CITY OF CODY
PLANNING, ZONING AND ADJUSTMENT BOARD
TUESDAY, MAY 24, 2016
CITY HALL COUNCIL CHAMBERS @ 12:00 NOON

CITY OF CODY PLANNING, ZONING AND ADJUSTMENT BOARD STAFF REPORT			
MEETING DATE:	MAY 24, 2016	***TYPE OF ACTION NEEDED***	
AGENDA ITEM:		P&Z BOARD APPROVAL:	X
SUBJECT:	SITE PLAN REVIEW: MODIFICATIONS TO WHITLOCK MOTORS PROJECT. SPR 2016-15	RECOMMENDATION TO COUNCIL:	
PREPARED BY:	TODD STOWELL, CITY PLANNER	DISCUSSION ONLY:

CITY OF CODY PLANNING, ZONING AND ADJUSTMENT BOARD STAFF REPORT			
MEETING DATE:	MAY 24, 2016	***TYPE OF ACTION NEEDED***	
AGENDA ITEM:		P&Z BOARD APPROVAL:	X
SUBJECT:	BEST WESTERN SUNSET MOTOR INN PERGOLA AND OUTDOOR SEATING SPR 2016-1	RECOMMENDATION TO COUNCIL:	
PREPARED BY:	TODD STOWELL, CITY PLANNER	DISCUSSION ONLY:

CITY OF CODY PLANNING, ZONING AND ADJUSTMENT BOARD STAFF REPORT			
MEETING DATE:	MAY 24, 2016	***TYPE OF ACTION NEEDED***	
AGENDA ITEM:		P&Z BOARD APPROVAL:	X
SUBJECT:	SITE PLAN REVIEW—CODY STAMPEDE OUTDOOR ARENA AND HORSE BARNS. SPR 2016-16	RECOMMENDATION TO COUNCIL:	
PREPARED BY:	TODD STOWELL	DISCUSSION ONLY:

1 AS1.1 Site Plan
1/8" = 1'-0"

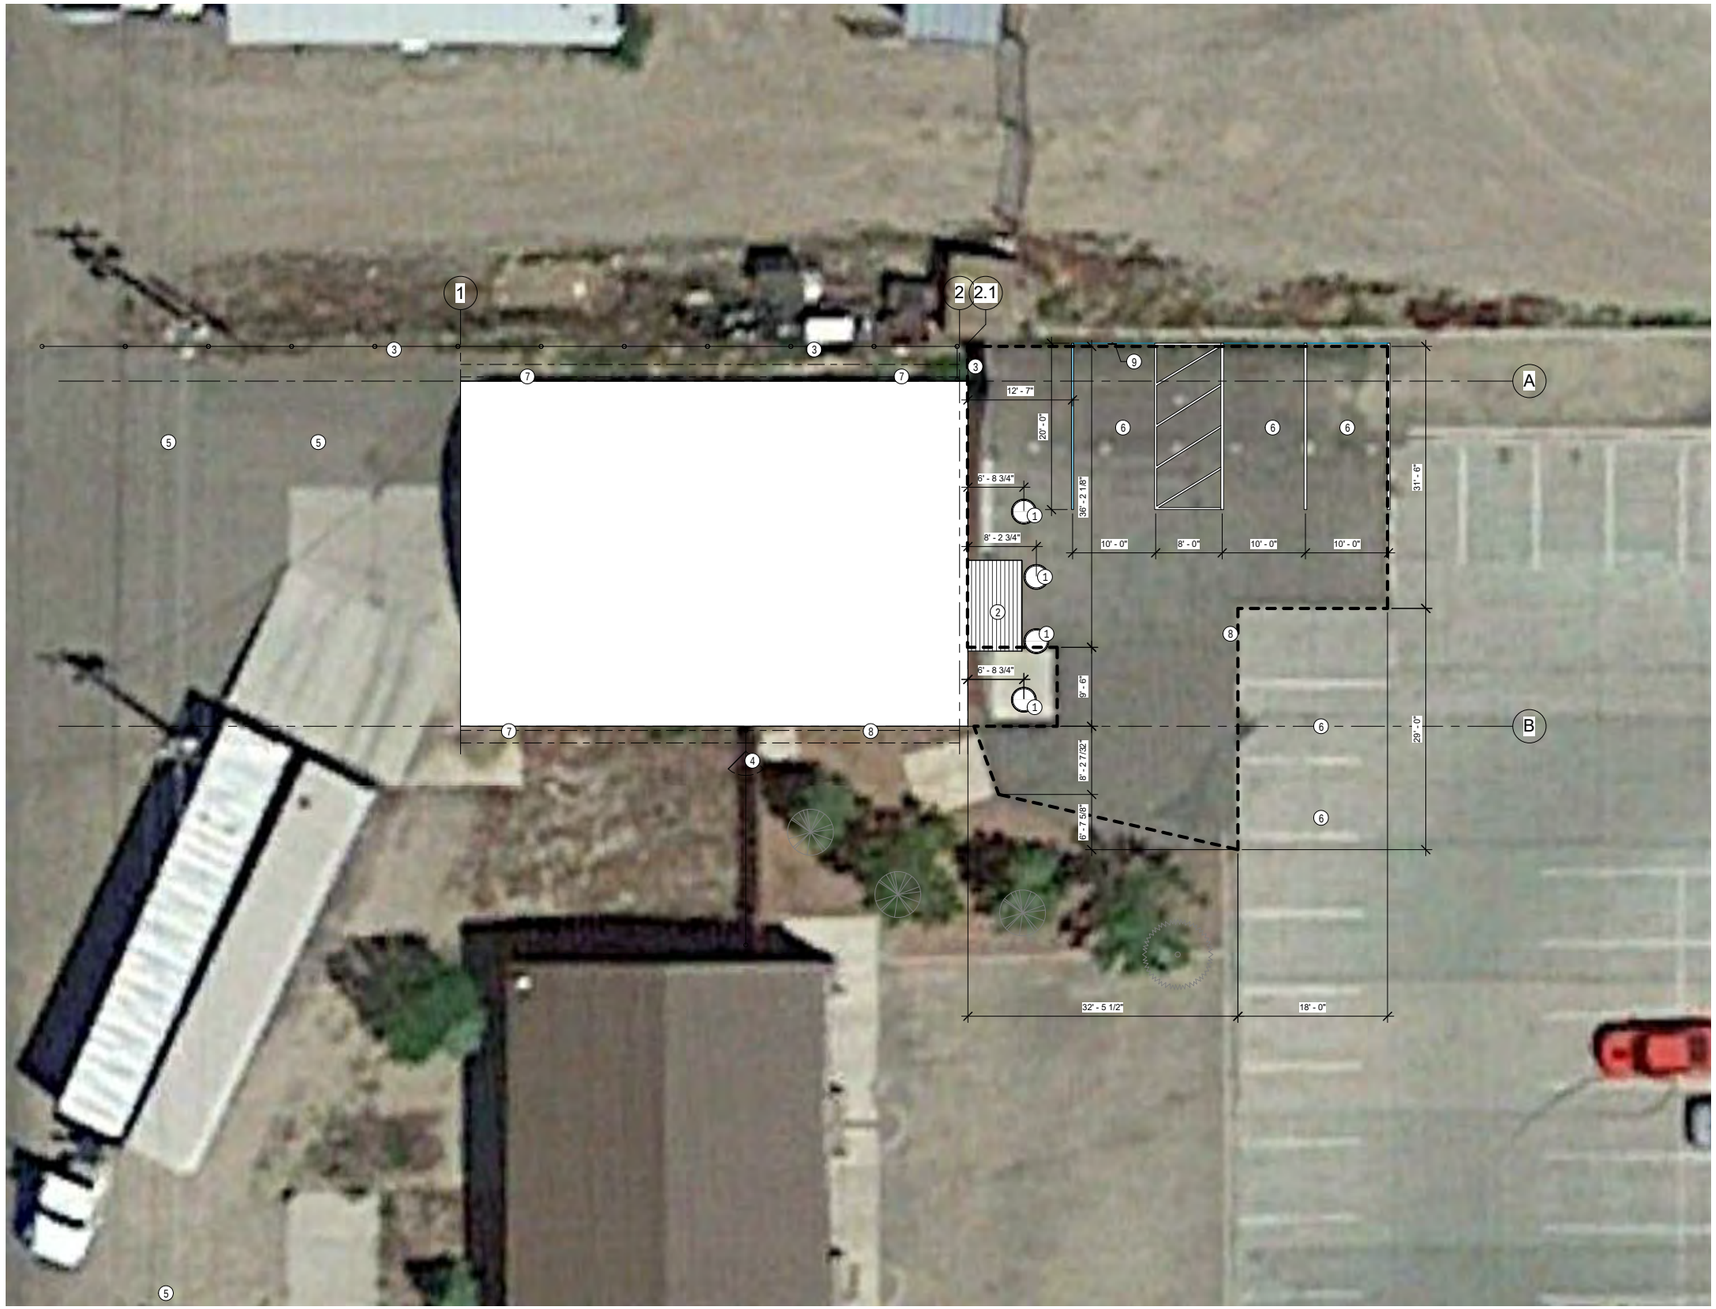
Setbacks/Buffers:
There are no zoning setbacks or buffers applicable to the project. The site plan does show a 6-foot slatted, chain link fence on the north side of the building, but it is not required by the zoning code.

SHEET C1 OF C1

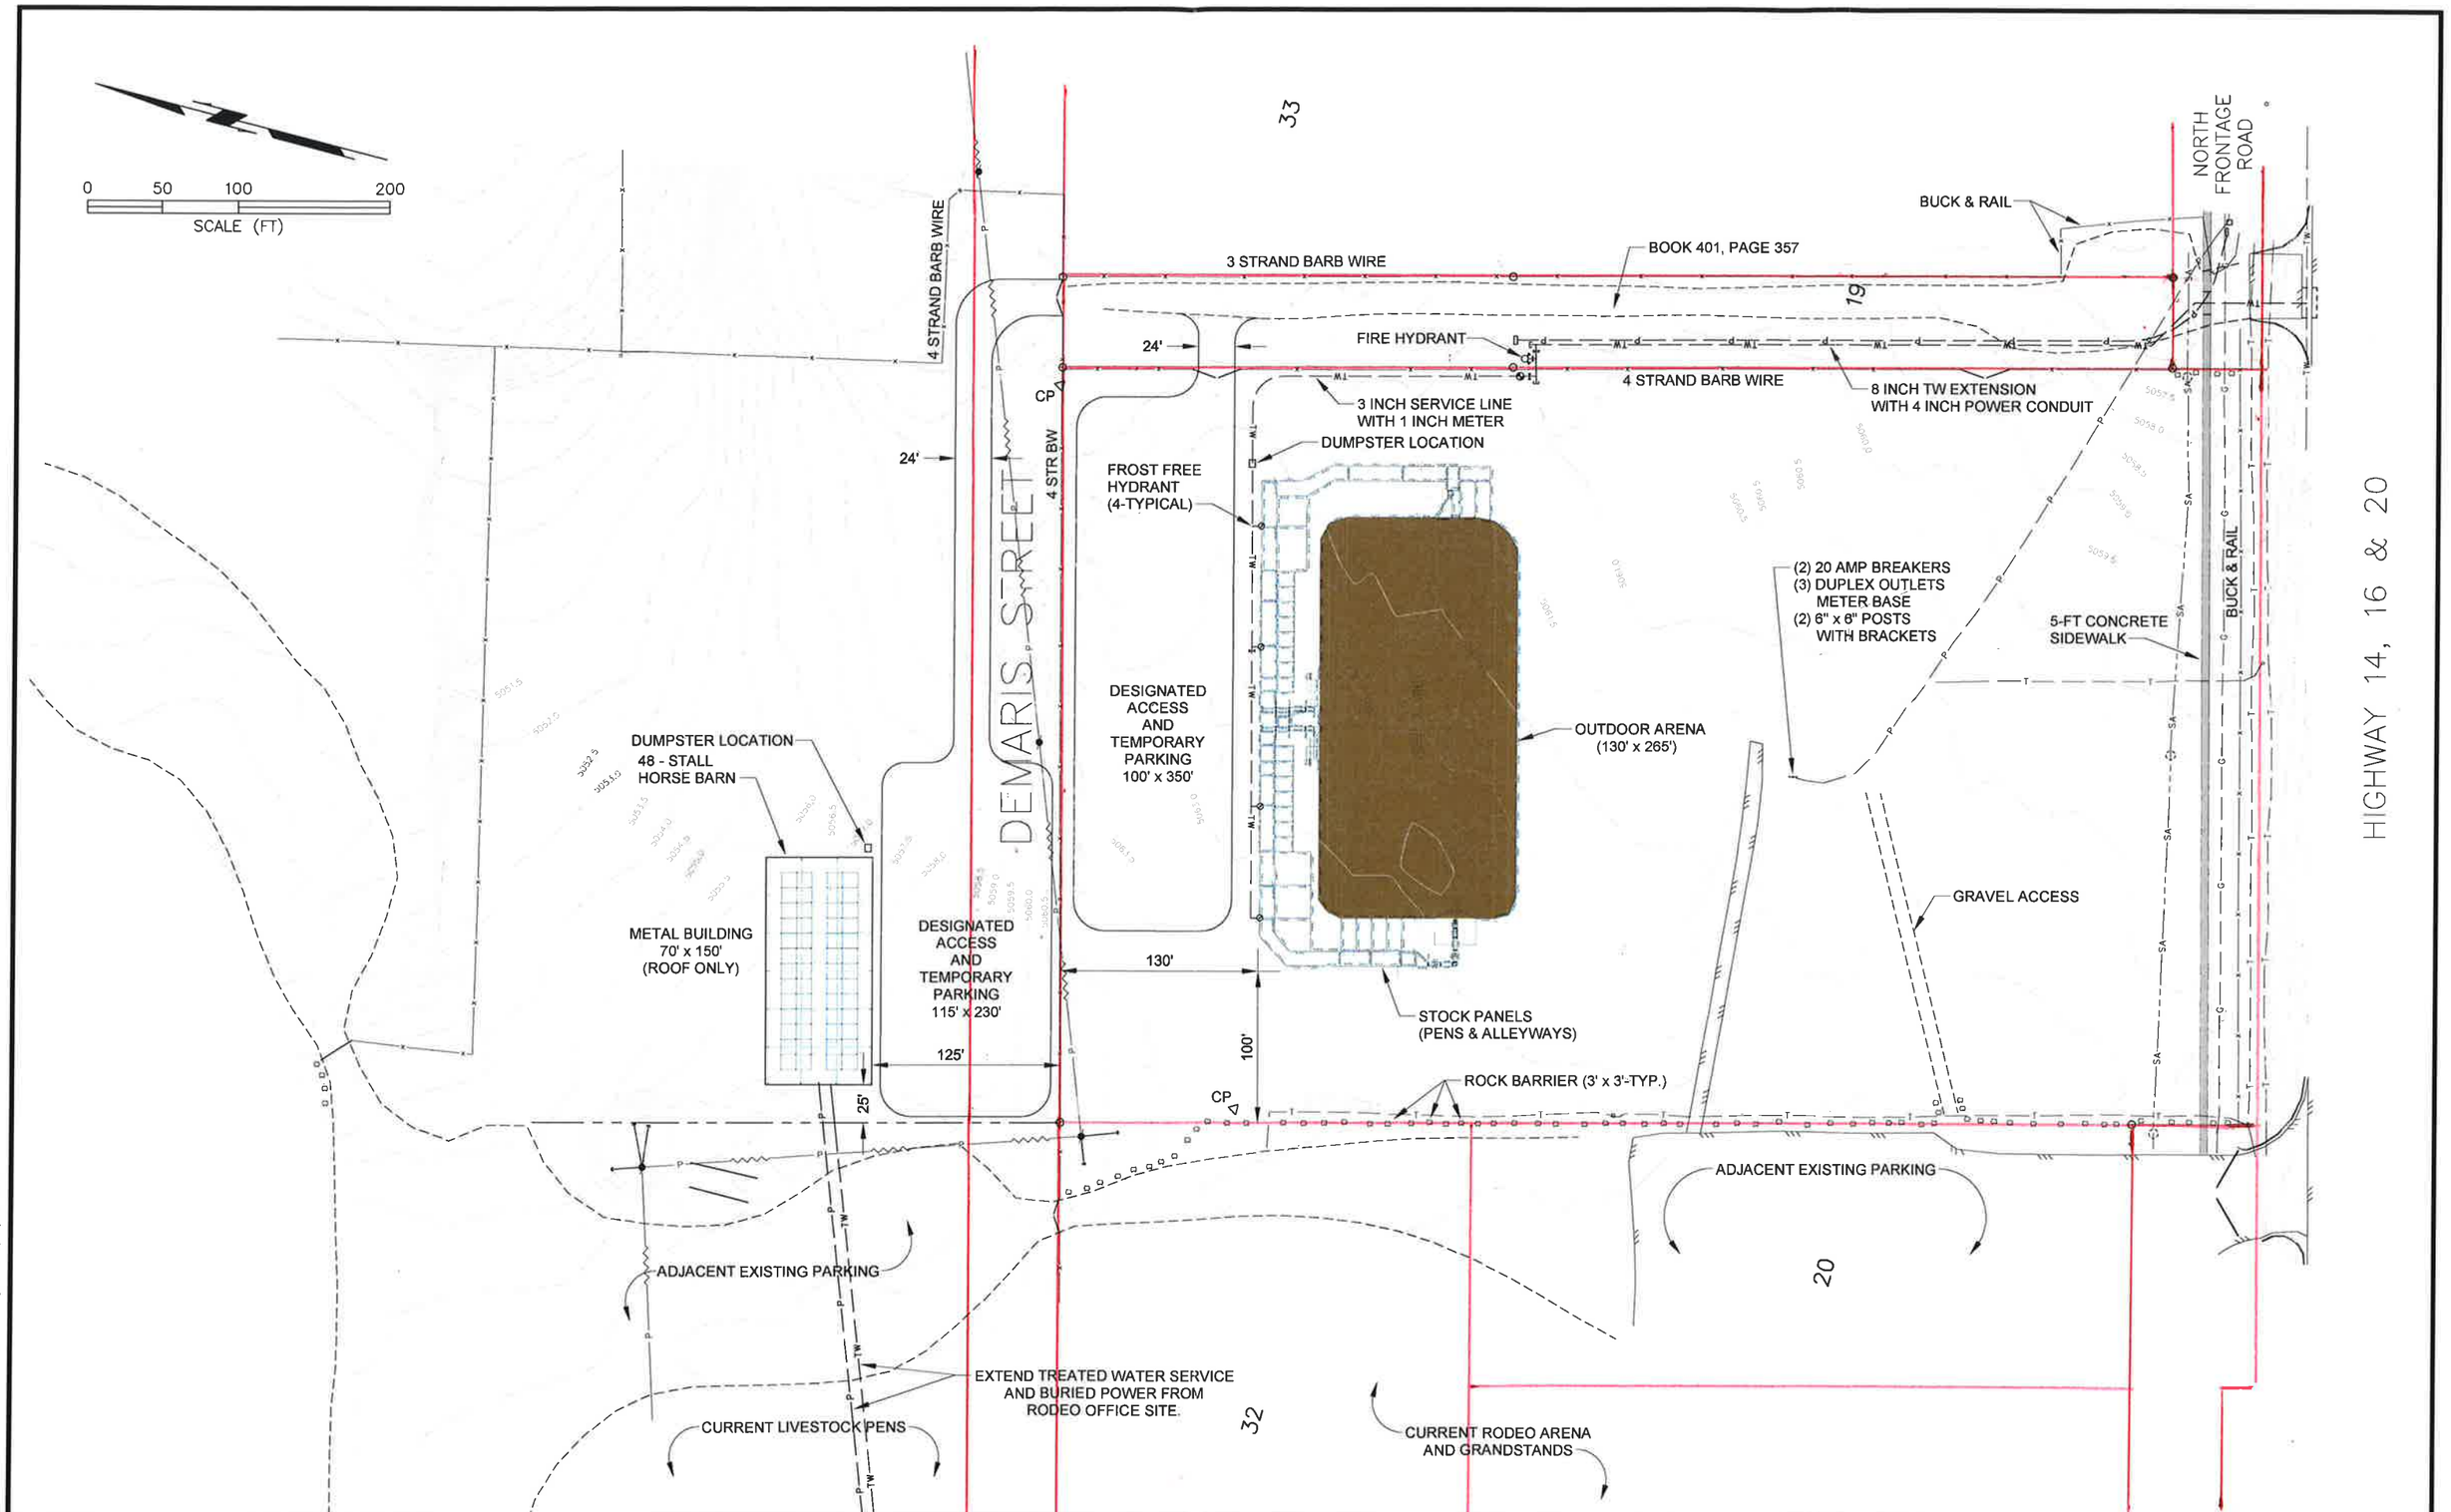
Access:
The application shows access from an existing approach on the east side of the property. However, the ownership of the 60-foot wide strip of land that the access road and utilities are planned to utilize is under review. To keep the project moving, the project will utilize access from the west, through the existing rodeo grounds parking lot; at least until the ownership situation is resolved.

Utilities:
The original plan included extension of a water main and service along the east side of the property. Electrical conduit for future electrical service is also planned to be installed in the same trench. The property ownership issue noted in the access section above precludes this utility work until the ownership situation is resolved. If the original plan is not resolved in a timely manner, extension of water from the rodeo grounds is an option.

1) There is some question as to whether the 60-foot wide strip of land in which the proposed access and utilities are to be located is owned by Cody Stampede. The deed referenced on the application does not include that area, nor does the legal description on the County Mapserver program, or the deed for the old drive-in property. Please research the issue and provide evidence of ownership. Alternatively, the site plan needs revised.

3) The encroachment license can also cover the grading in the DeMaris Street right-of-way area. However, we need a grading plan for that area to know what is proposed. Please provide a grading plan for the area in the immediate vicinity of the DeMaris Street right-of-way.

4) There is a Rocky Mountain Power line within the project area. Please contact Rocky Mountain Power to verify the easement width for the line, and that they are agreeable to the grading that will occur in the easement. Provide documentation of their acceptance.
Response: We are currently researching the existing powerline located in or near the platted Demaris Street. It appears to belong to Rocky Mountain Power. These power easements are very old and difficult to track down. We recognize that the street vacation may need to be replaced with a utility easement for this powerline and other future utilities.

Response: We are currently researching documentation regarding the 60-ft strip designated as an access and easement corridor along the east edge of the project. Until this issue can be resolved, Cody Stampede Board proposes to utilize the existing access from West Yellowstone Ave. that passes through the main Stampede Grounds overhead gateway for access to the horse stall barn and new outdoor arena. No work will be done in the east corridor until this issue is resolved.

SHEET A1 OF A1

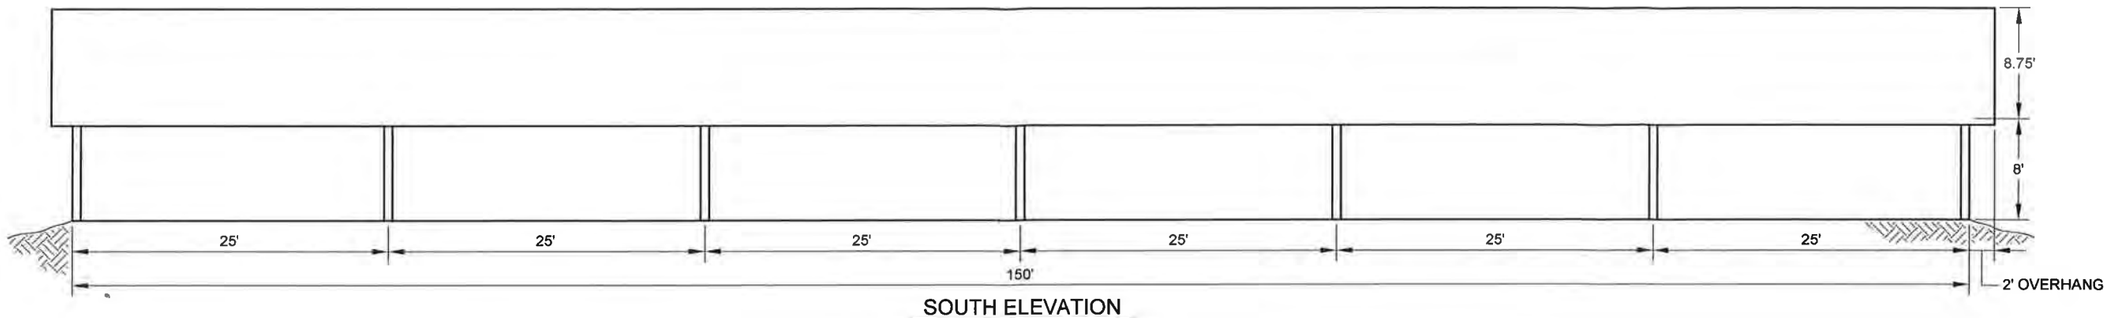
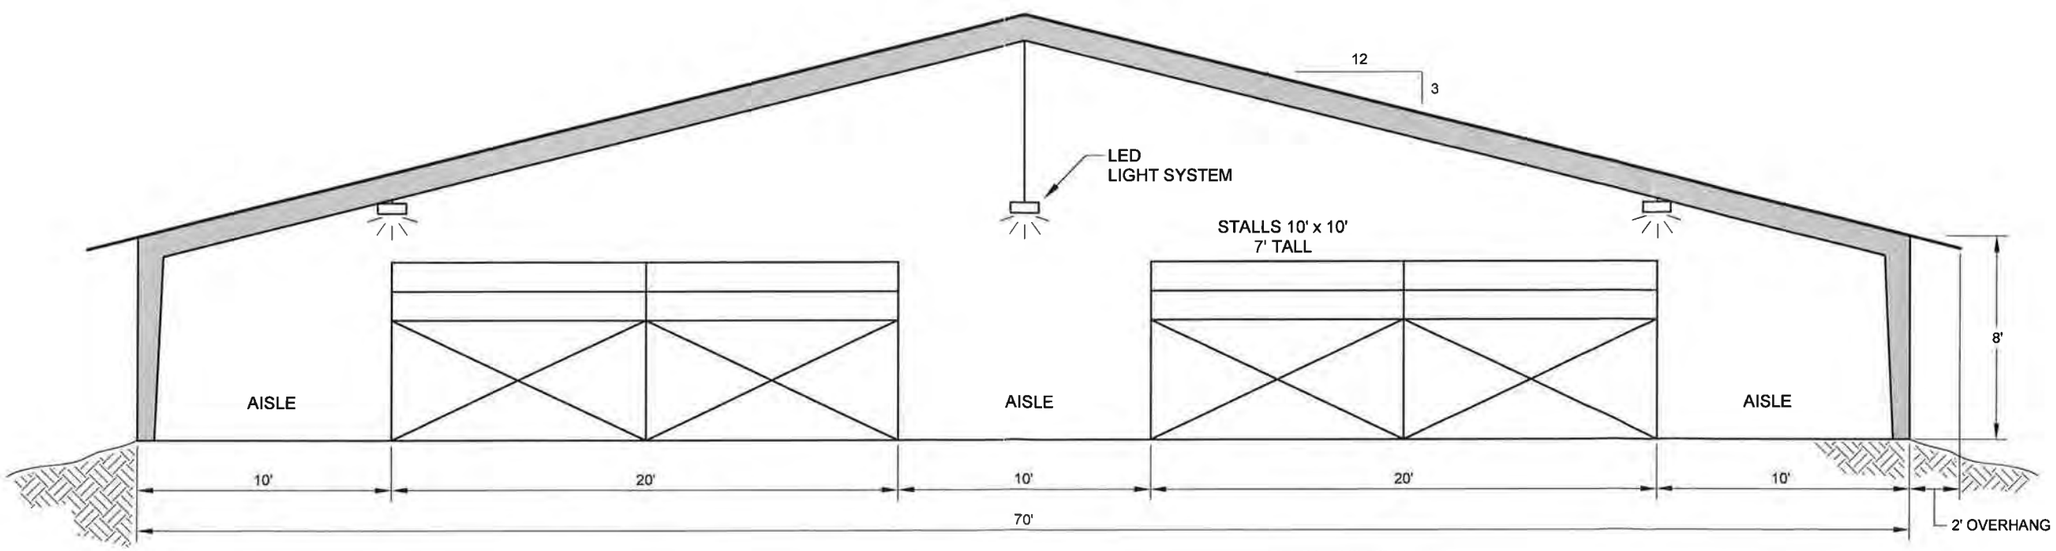
The only building that is part of this project is the horse barn. Architecturally, it is an open-walled metal building with a 3:12 pitched roof. The roof covering will be the standing seam galvalume coated steel, which is what is on the main rodeo stadium roof. Building dimensions are 70 feet wide, 150 feet long, and 17 feet tall. The horse stalls within the building will each be 10’ by 10’ and formed by 7-foot tall stock panels. An under-roof LED lighting system will be used for lighting of the horse stalls and aisles. See Sheet A1.
